Proposal Request

PROPOSAL REQUEST 112

Dishwasher Exhaust

PROJECT: AWSOM
BENTONVILLE, AR

1 HVAC - LEVEL 2 PLAN - AREA A
1/8" = 1'-0"

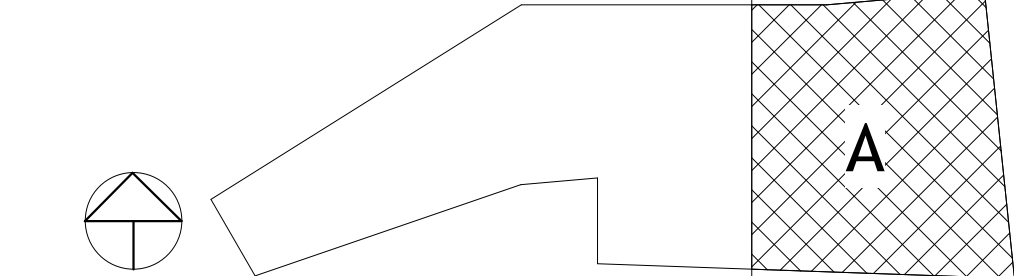
- 1) **Mechanical**
 - a) Revised Sheet M102A
 - Added keyed note 212 to call out fire wrap of the dishwasher exhaust duct.
 - b) Revised Sheet M103A
 - Added keyed note 212 to call out fire wrap of the dishwasher exhaust duct.
 - c) Revised Sheet M104A
 - Added keyed note 212 to call out fire wrap of the dishwasher exhaust duct.

- M212 FIRE WASH DISHWASHER EXHAUST DUCT FROM LEVEL 3 FLOOR PENETRATION TO FLOOR CURE AND SEAL AT FLOOR PENETRATIONS. FOLLOW ALL MANUFACTURER INSTALL REQUIREMENTS AND DETAILS.
